Tennessee Valley Authority, 1101 Market Street, Chattanooga, Tennessee 37402

Browns Ferry Nuclear Plant, Units 2 and 3
Facility Operating License Nos. DPR-52 and DPR-68
NRC Docket Nos. 50-260 and 50-296

Subject: Supplement to Technical Specification Change TS-429 – Deletion of Low Pressure Coolant Injection Motor-Generator Sets for Browns Ferry Nuclear Plant, Units 2 and 3

REVISED EVALUATION FOR TECHNICAL SPECIFICATION CHANGE TS-429
Deletion of Low Pressure Coolant Injection Motor-Generator Sets for
Browns Ferry Nuclear Plant, Units 2 and 3

Figure 2, Resulting Configuration of Portion of BFN, Unit 2, Electrical Distribution System Associated with Planned Change

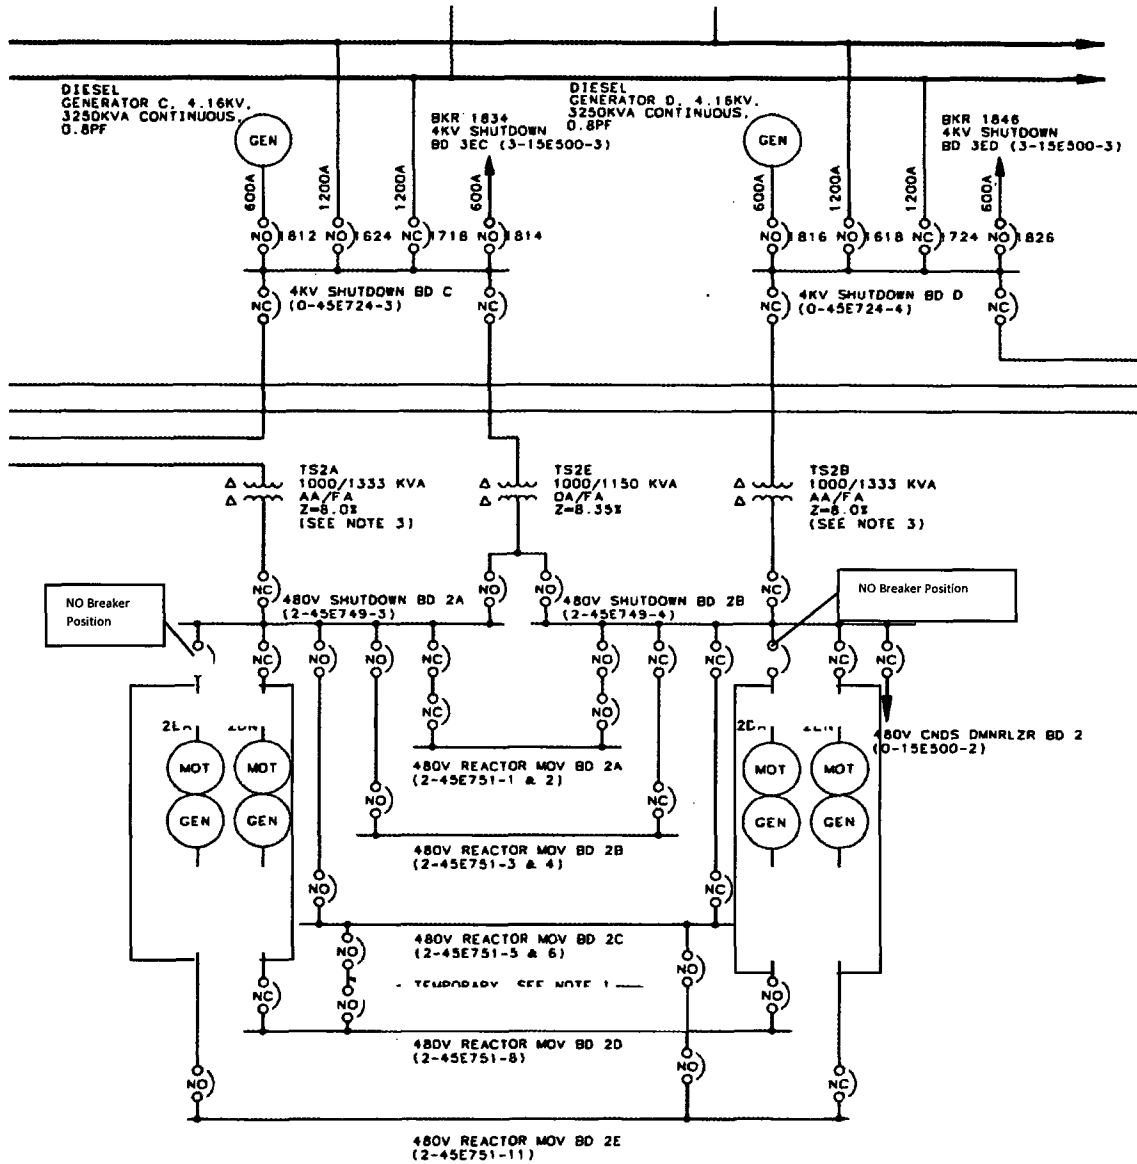
1. BFN, Units 2 and 3, LPCI MG Sets DN, DA, EN, and EA and their locally mounted instrumentation and controls will be removed from service and abandoned in place.
2. Instead of RMOV Boards D and E being powered from the LPCI MG Sets, they will be powered directly from the corresponding 480V Shutdown Boards through their normal feeds.
3. The feeder breakers for 480V RMOV Boards D and E at the applicable 480V Shutdown Boards will be modified from electrically operated to mechanically operated.
4. The alternate feeder breakers for 480V RMOV Boards D and E at the applicable 480V Shutdown Boards will be changed from normally closed to normally open.

After the planned change, the resulting configuration of the portion of the electrical distribution system associated with this planned change will be as shown in Figures 2 and 4 for BFN, Units 2 and 3, respectively.

Figure 4, Resulting Configuration of Portion of BFN, Unit 3, Electrical Distribution System Associated with Planned Change

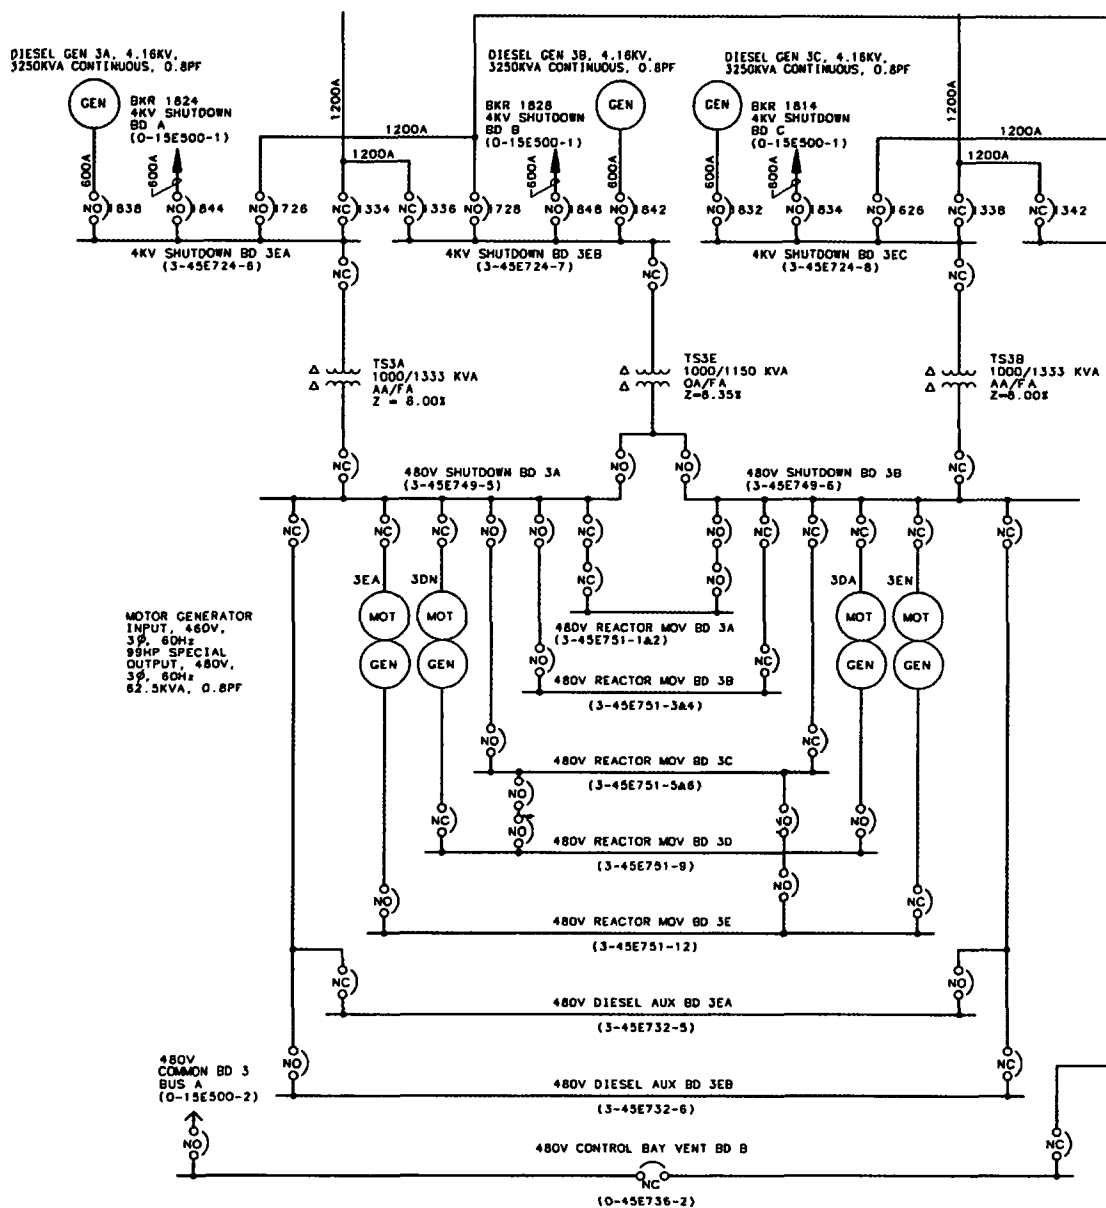
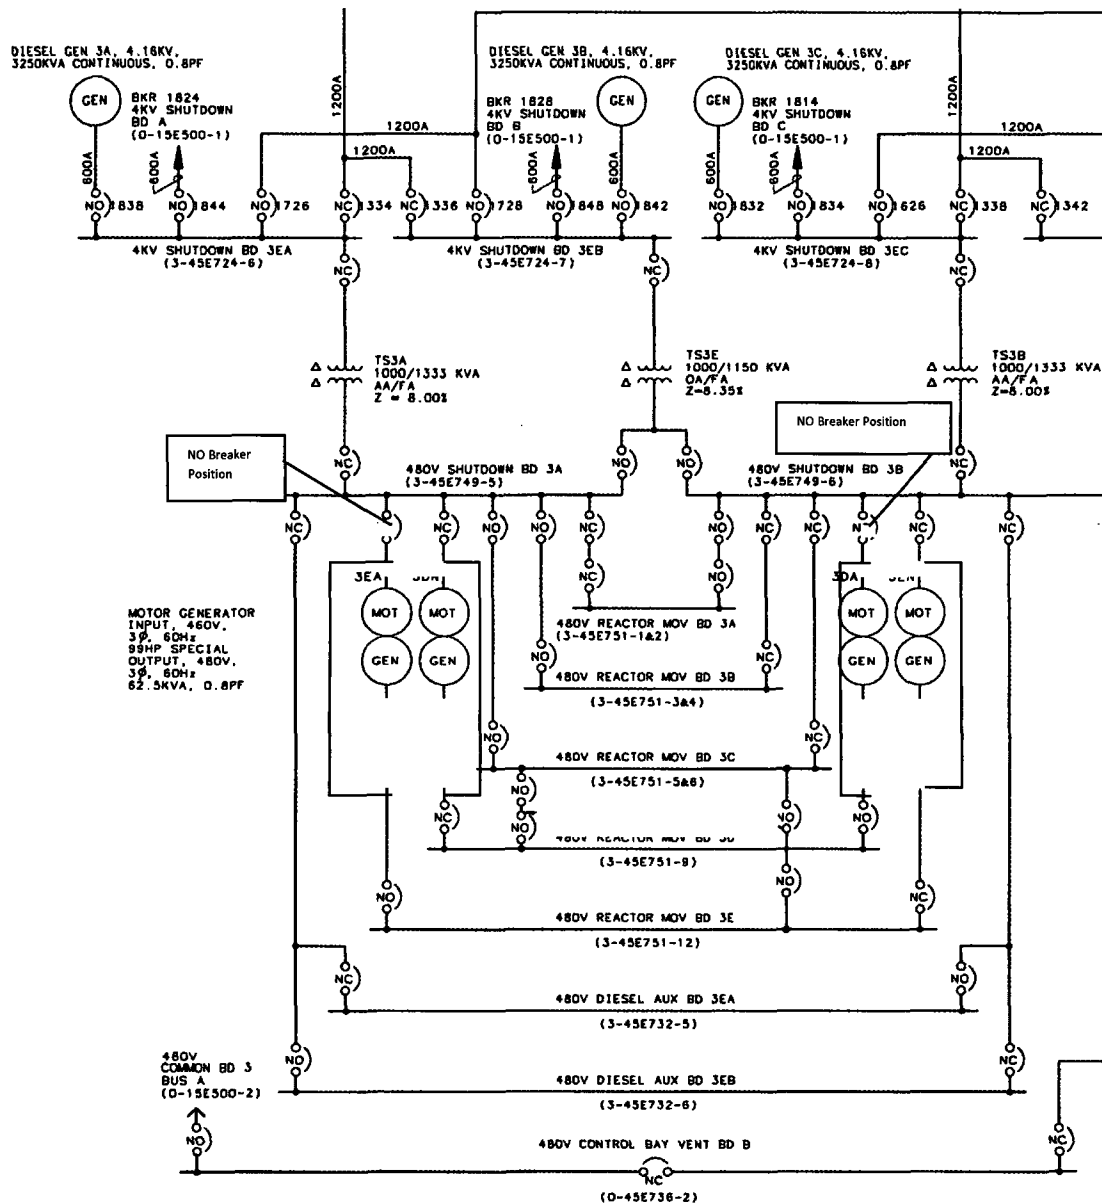
The current configuration of the portion of the electrical distribution system associated with this planned change is shown in Figures 1 and 3 for BFN, Units 2 and 3, respectively.
